SITE INVESTIGATION REPORT
INDIVIDUAL SEPTIC TANK SYSTEM
WITH SUBSURFACE,
SOIL ABSORPTION,
EFFLUENT DISCHARGE

SIR.NO. _____
T.C. NO. 15098
MAP DATE po 215-092-08
DATE June 19, 1979

NAME OF OWNER Mr. Paul A. Vogler

LOCATION OF LOT Highway 74, East Lot 3

* See Diagram on Back (Include: Soil areas, property lines, roads, streams, gullies, wet areas, fill areas, wells, water bodies, slope patterns)

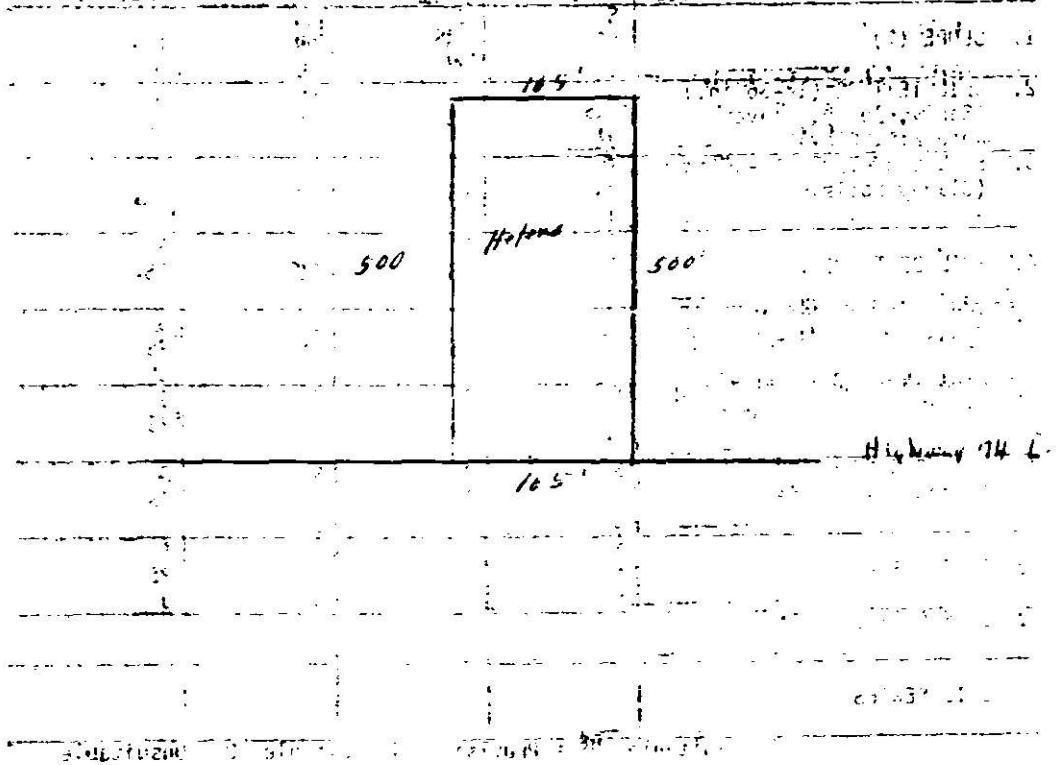
Soil Structure Massive
Perched Water Table
Soil Permeability Unsuitable
Site Classification Unsuitable

Inadequate area available for installation of ground absorption sewage disposal system in accordance with North Carolina Department of Human Resources specifications.

FACTORS	AREA 1	AREA 2	AREA 3	AREA 4
1. SLOPE (%)	(S) PS 2-6% U	S PS U	S PS U	S PS U
2. SOIL TEXTURE (12-36 in.) (Sandy, loamy, clayey, Note 2:1, Clay)	S PS 2:1 Clay (U)	S PS U	S PS U	S PS U
3. SOIL STRUCTURE (12-36 in.) (Clayey Soils) ✓	(S) Massive PS U	S PS U	S PS U	S PS U
4. SOIL DEPTH (In.)	(S) PS 40" U	S PS U	S PS U	S PS U
5. RESTRICTIVE HORIZONS (In.) (Impervious Strata, Rock)	(S) None PS U	S PS U	S PS U	S PS U
6. SOIL DRAINAGE/GROUNDWATER (External & Internal) ✓	S Seasonal PS Perched (U) water Table	S PS U	S PS U	S PS U
7. SOIL PERMEABILITY (Percolation Rate) ✓	S PS (U) Slow	S PS U	S PS U	S PS U
8. OTHER (Specify)	S PS U	S PS U	S PS U	S PS U
9. SITE CLASSIFICATION ✓	Unsuitable			
SOIL SERIES	Helena

* See Diagram on Back (Include: Soil areas, property lines, roads, streams, gullies, wet areas, fill areas, wells, water bodies, slope patterns, etc)

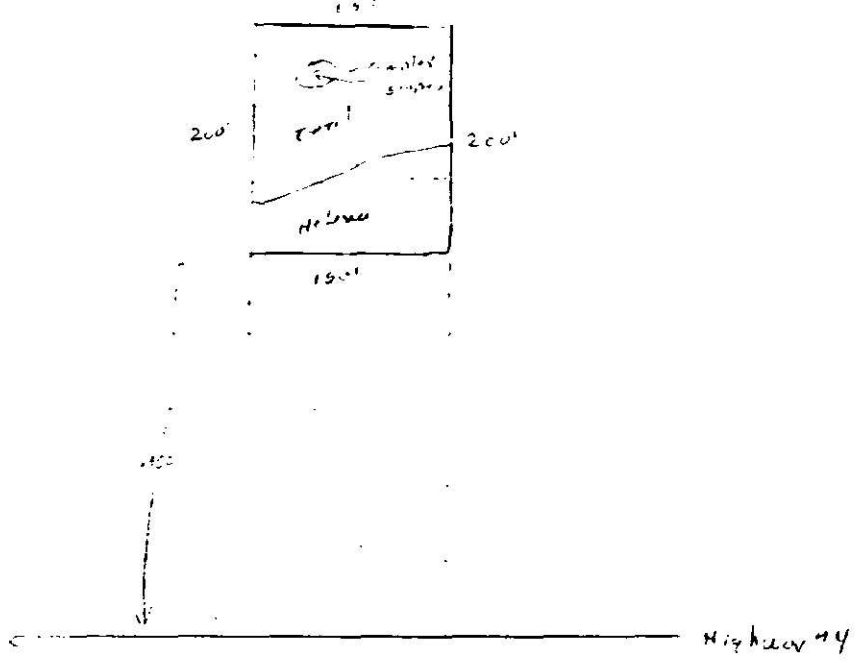
FACTORS	AREA 1	AREA 2	AREA 3	AREA 4
1. SLOPE (%)	(S) 2-6% PS U	(S) PS 2-6% U	S rolling PS slopes U	S PS U +
2. SOIL TEXTURE (12-36 in.) (Sandy, loamy, clayey, Note 2:1, Clay)	S (PS) clay U	S 2:1 PS clay U	S (PS) clay U	S PS U

3. SOIL STRUCTURE (12.36 in.) (Clayey Soils)	S (PS) Blocky U	S PS Massive U	S (PS) Blocky U	S PS U
4. SOIL DEPTH (In.)	(S) 40" PS U	(S) 40" PS U	S 12-20" PS Variable U	S PS U

5. RESTRICTIVE HORIZONS (In.) (Imprevious Strata, Rock)	(S) None PS U	(S) None PS U	S None PS U	S PS U
6. SOIL DRAINAGE/GROUNDWATER (External & Internal)	(S) 24-36" PS Grand U Water	S Seasonal PS Perched U Water Table	S Limited PS Areas, Channel U Water	S PS U

7. SOIL PERMEABILITY (Percolation Rate)	S (PS) Moderate U	S PS Slow U	S (PS) Moderate U	S PS U
8. OTHER (Specify)	S (PS) Limited Area U	S PS U	S PS U	S PS U

9. SITE CLASSIFICATION	Provisionally Suitable	Unsuitable	Prov. Suitable	
SOIL SERIES	Coxville	Johnston	Exum/Mixed Alluvial
